Applicant's Comments on the Written Representations

August 2012
Revision: 0
Able UK Ltd

ABLE MARINE ENERGY PARK APPLICANT'S COMMENTS ON THE WRITTEN REPRESENTATIONS	AUGUST 2012

Figure 3.2 Revised Assessment of Construction Vessel Movements Reported in ES

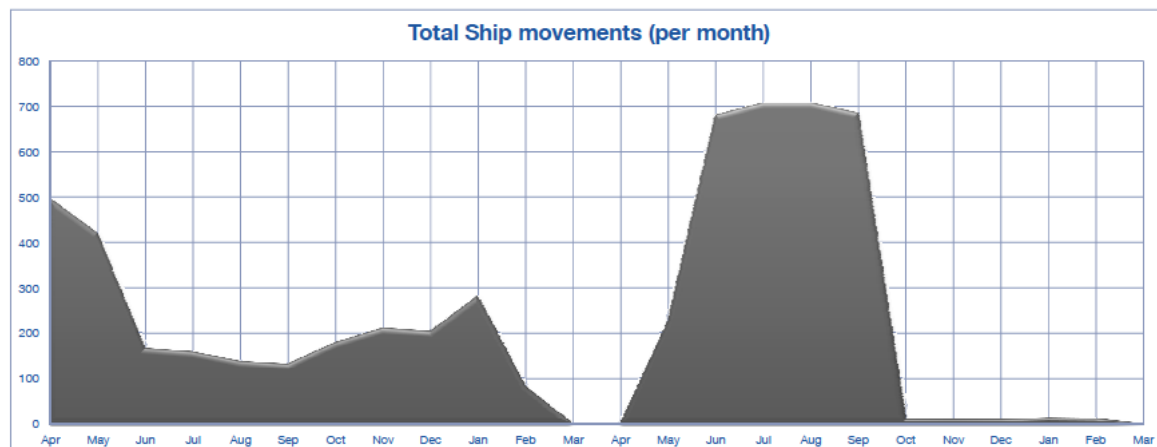
- 3.8 The references to *'a 600% increase in traffic within C.RO's area of operation'*, needs to be set in context. The assessment of vessel movements was reviewed following the preparation of the navigational risk assessment and the total number of construction vessel movements increased from 3 600, stated in Annex 14.2, to 5 500 as stated in the ES; refer to Figures 3.1 and 3.2 below which illustrates how this change arose. However, the EIA had regard to this change as recorded in Section 14.2 of the ES. As can be deduced from a comparison of the figures below, the increase from a peak of 400 vessel movements per month to 700, is substantially due to **one** extra split hopper barge (from two to three) being used in association with the backhoe dredger, together with modified assumptions on production rates. The backhoe dredger will be, to all intents and purposes, static, and will be operating predominantly within the berthing pocket, allowing the free passage of ships for most of the time. The number of vessel movements will also decrease significantly following the identification of beneficial use for glacial clay deposits within the berthing pocket. This is reported in EX7.7 included in the volume of supplementary information.

Figure 5.5 Plan showing location of Centrica intake and adjacent dredge areas.

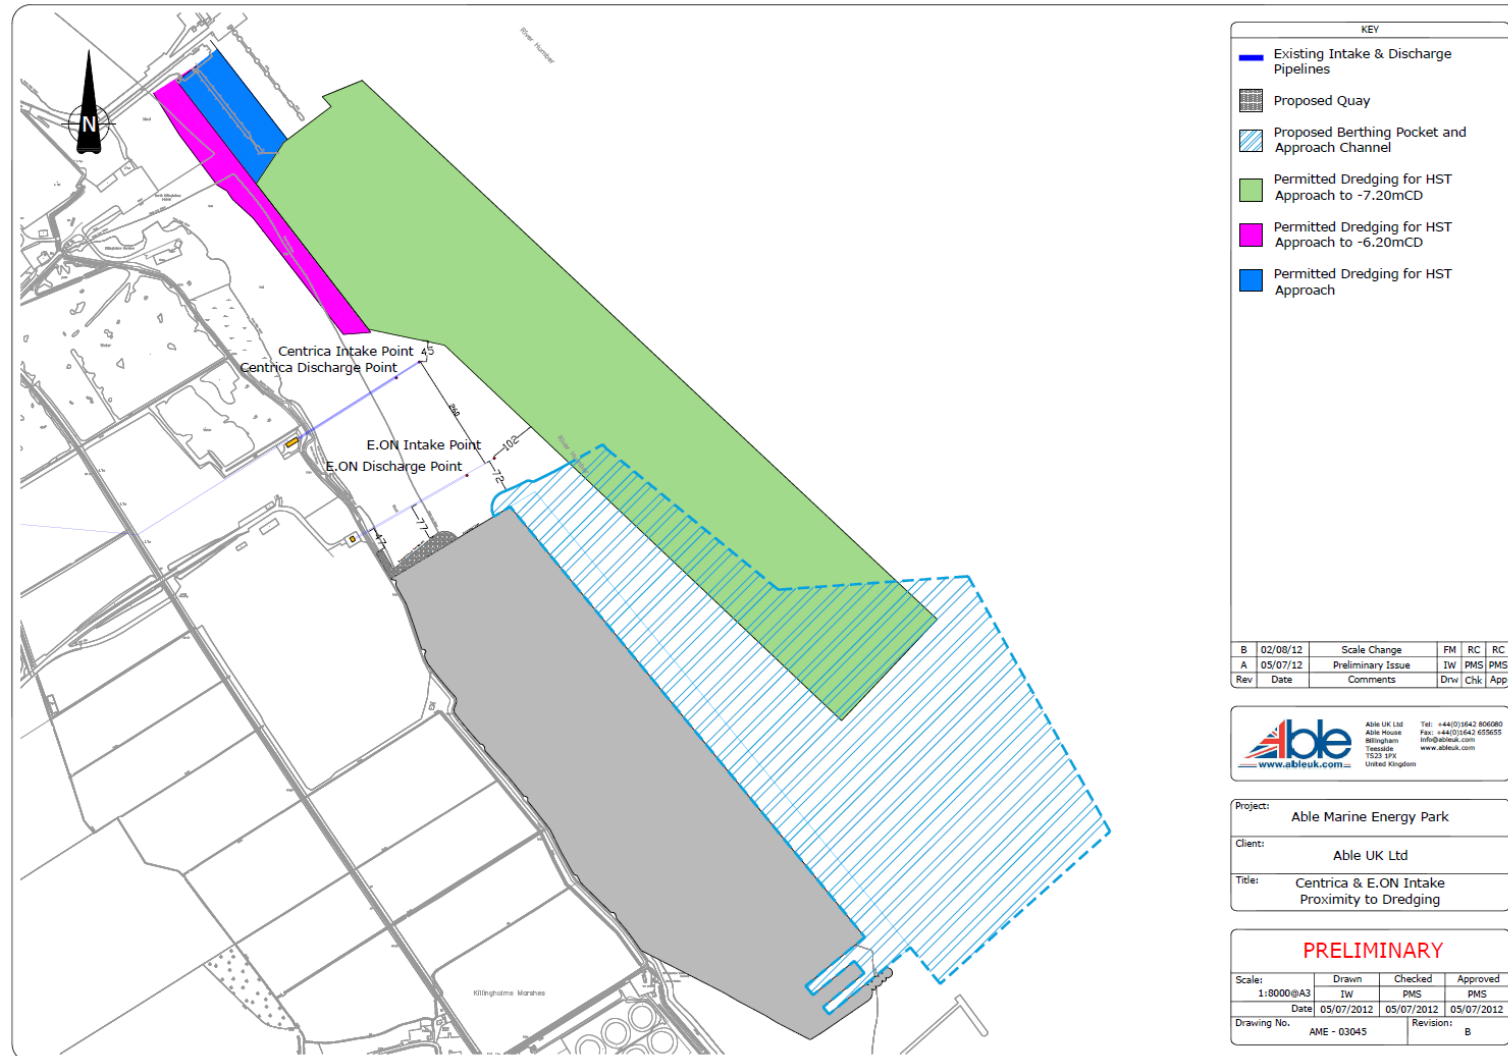
- 5.15.1 Centrica's intake is currently less than 50m from the dredged channel on the approach to the Humber Sea Terminal, refer to Figure 5.5. Centrica confirmed at a meeting held on the 6th July 2012 between that they are not notified when dredging operations are carried out by HST and that dredging does not have any impact upon the operation of the inlet or the power station cooling water system.

Figure 6.1 : Abstract from Drax FRA Showing Flood Depths Following a 20m Breach of the Sea Wall to a Level of 4.5mAOD in 2084 (0.4-0.8m)

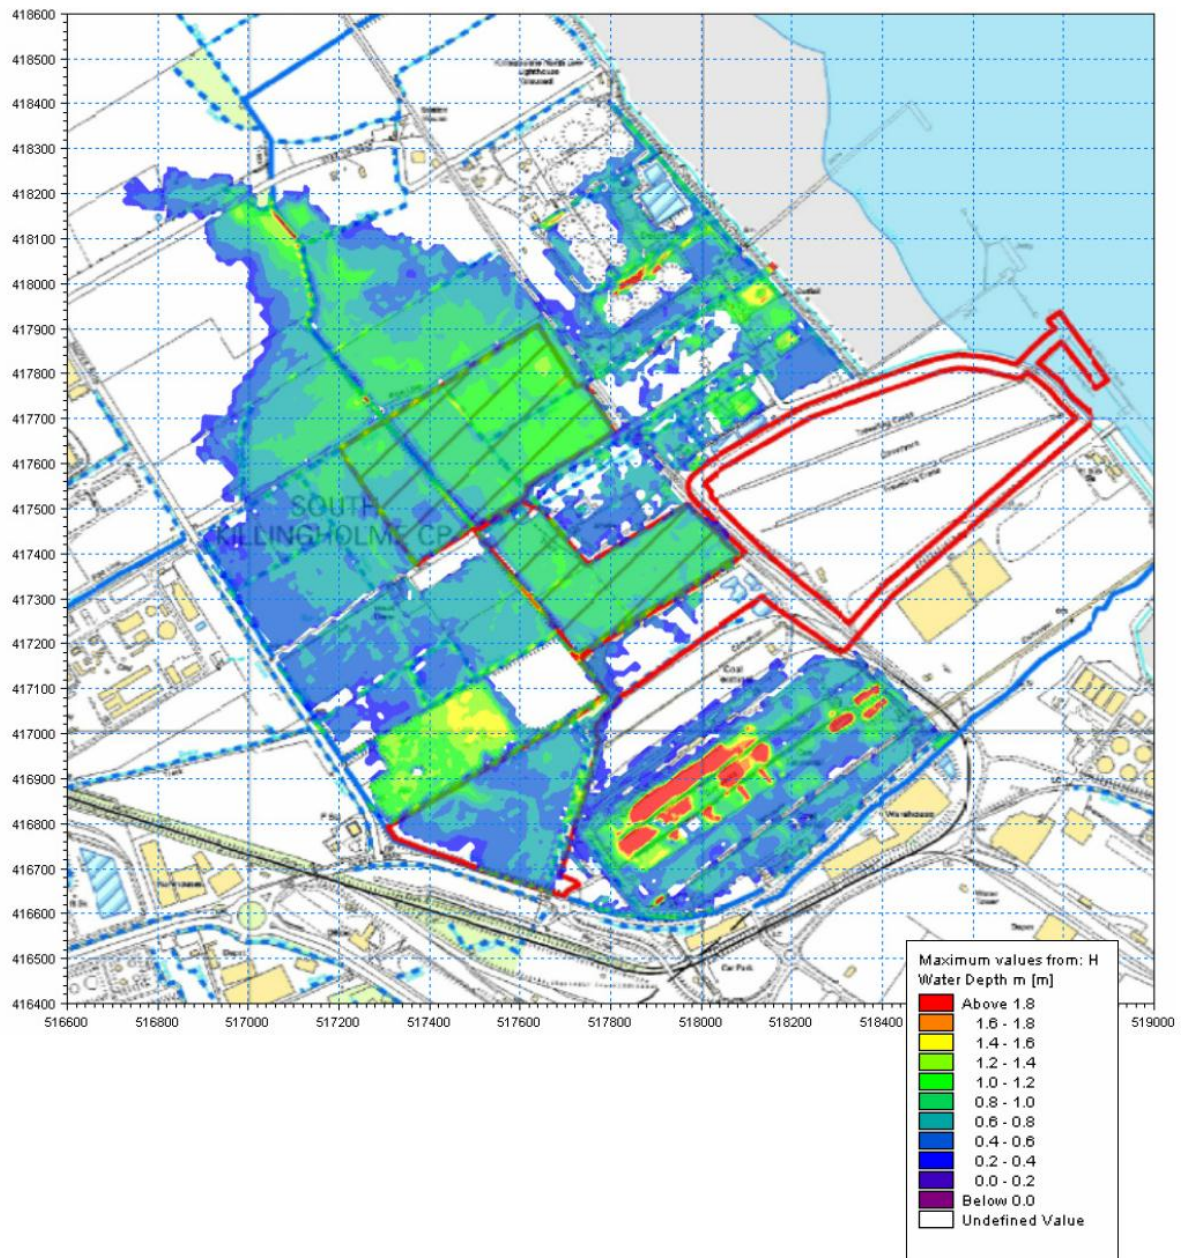
6.6 In summary therefore, the breach modelling undertaken by Drax and AMEP are very different. In the Drax FRA, the level of flooding on Killingholme Marshes is predicted to be 3.28 mAOD in 2084, and the depth of flooding predicted is shown in Figure 6.1 below. However, the depths indicated are patently inconsistent with the EAs own flood mapping, reproduced in Figure 5.2, which shows present day flooding to be significantly greater than predicted by Drax after 75 years.

6.7 In conclusion of the above, the Applicant agrees that the depth of flooding is likely to increase at the Drax site to some extent, but that the increase will be less than 300mm within the lifetime of the Drax development. The Drax breach modelling appears to be optimistic and may be underestimating flood depths. However, if, notwithstanding the above points, the Drax FRA is considered valid, then the increase in flood depths on the Drax site due to AMEP is likely to be very limited because, as is evident from Figure 6.1, little of the flood water is actually stored within raised areas of the AMEP so the impact of AMEP will be minor.

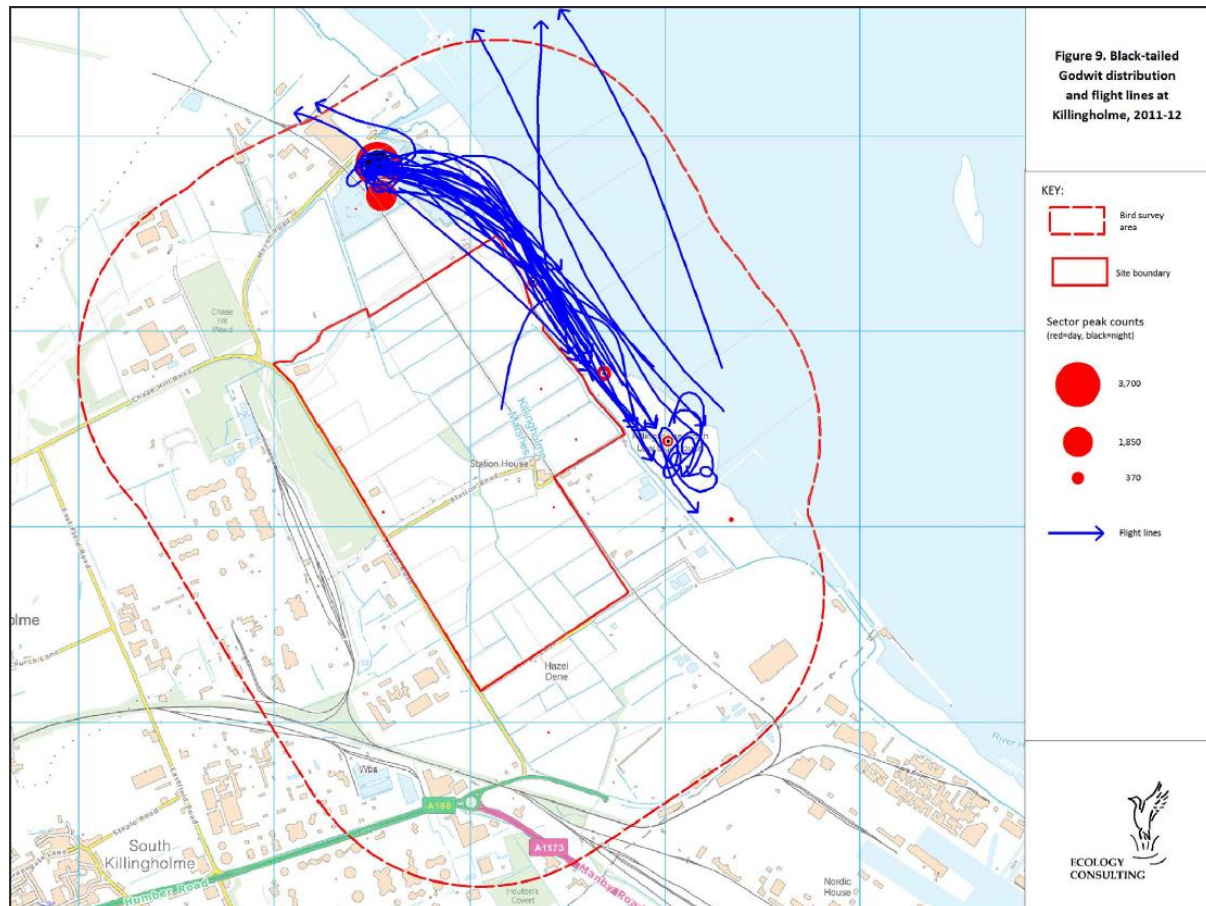
17.12 The statement in Annex 35.6 that the BTGs will choose the shoreline as a flight-path rather than overflying land, and would therefore divert around the quay rather than be constrained by a reluctance to overfly it, is supported by the

figure below, extracted from the *Able Marine Energy Park Non-Breeding Bird Surveys 2011-12*, Dr Steve Percival, Tracey Percival and Tom Lowe (Ecology Consulting), March 2012. This figure shows the routes adopted by the black-tailed godwit population at present when moving to feeding grounds more distant from the Pits than the Killingholme Marshes foreshore.

Figure 18.1 : Proposed Route of Diverted Sludge Mains

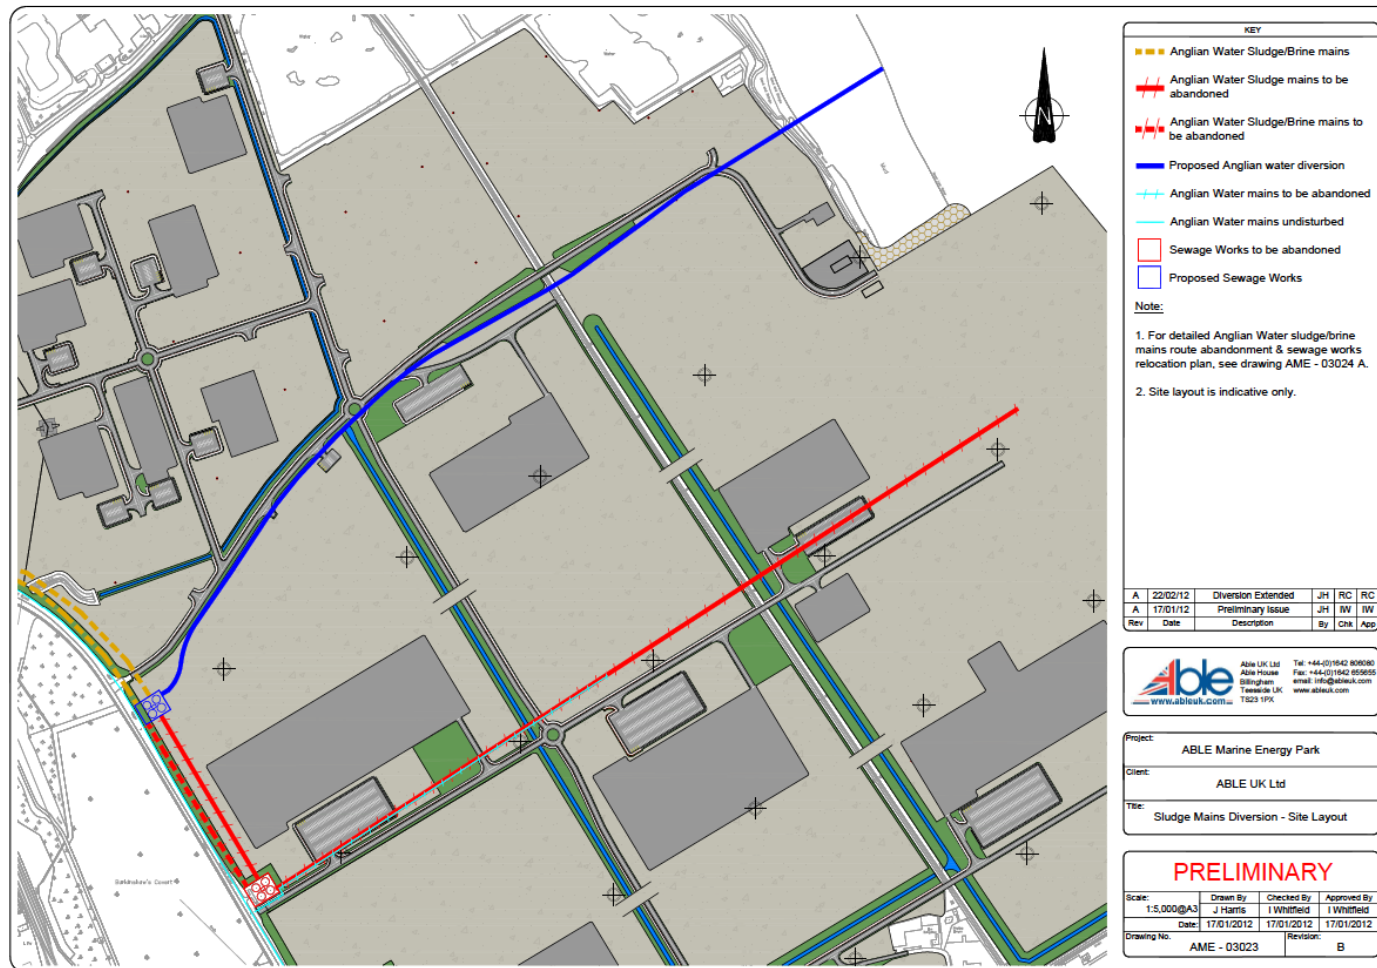
- 18.7.2 In fact, a plan showing the diversion route had first been issued to Anglian Water on 6th October 2010 and was re-issued on 5th April 2011. The proposed diversion route has been shown consistently; the drawing issued with the S185 application is shown in Figure 18.1.

Figure 22.4 Abstract from Land Plan 3 (top) and Indicative Masterplan for AMEP (bottom)

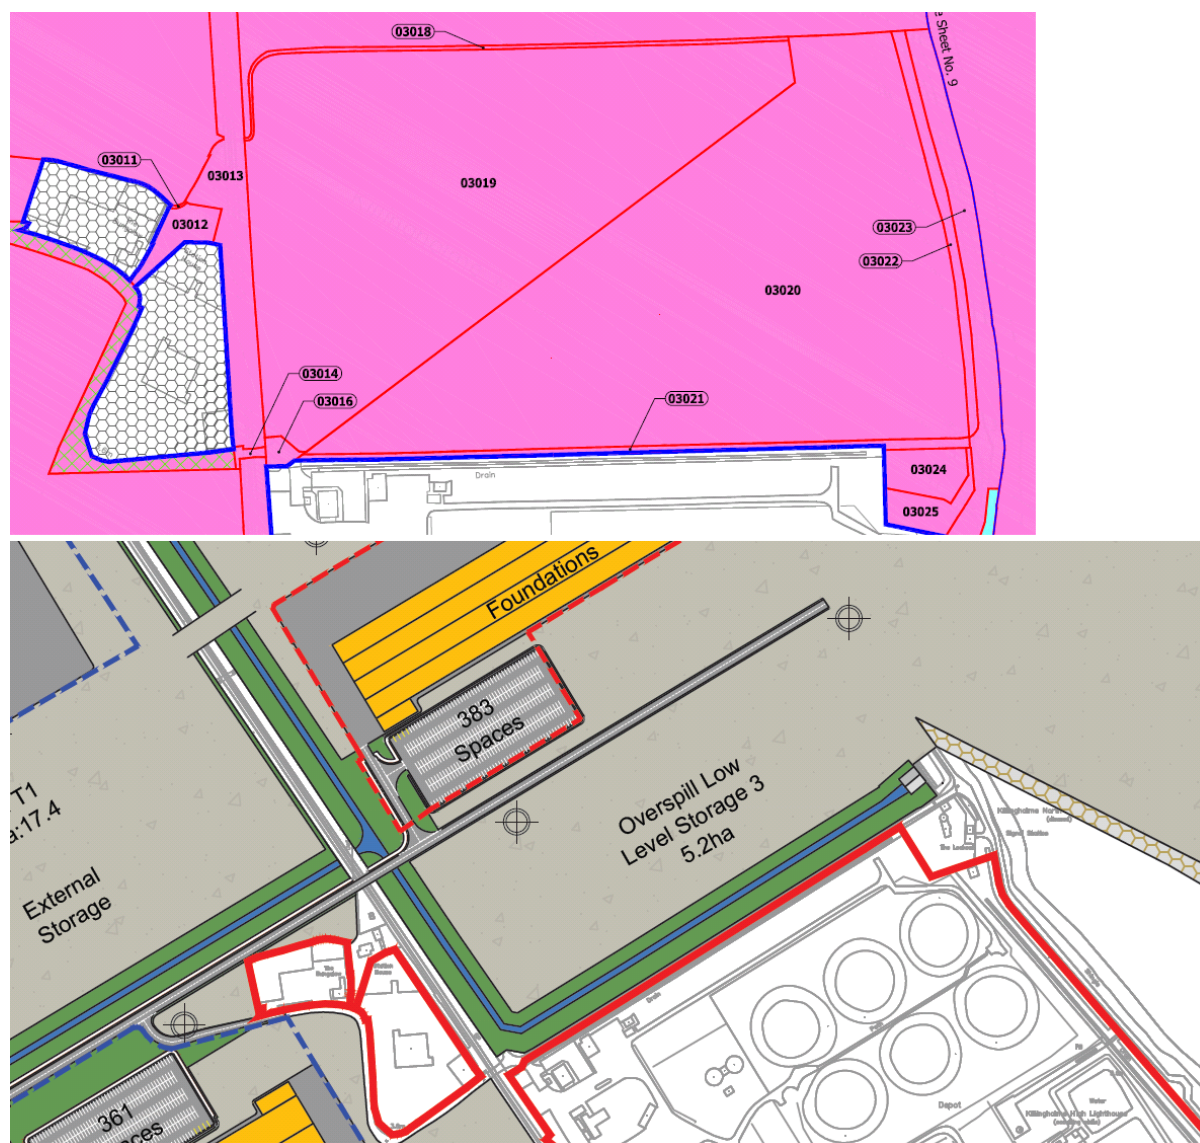
22.239 At paragraph 6.8, Mr Fitzgerald states that the Applicant's use for the land is for a pumping station and overspill low level storage. At Figure 22.4 is the relevant extract from the land plan together with the relevant extract from the indicative masterplan from the ES. While the pumping station is indeed planned to occupy one edge of the triangle, he omits to mention that the quay will occupy the entire of the remainder of the frontage of the triangle site. The pumping station must necessarily be at one side of the quay. 'Low level' is not to imply 'low priority', it is low in terms of height to minimise its impact on the environment, an issue that would also affect any proposal by ABP.
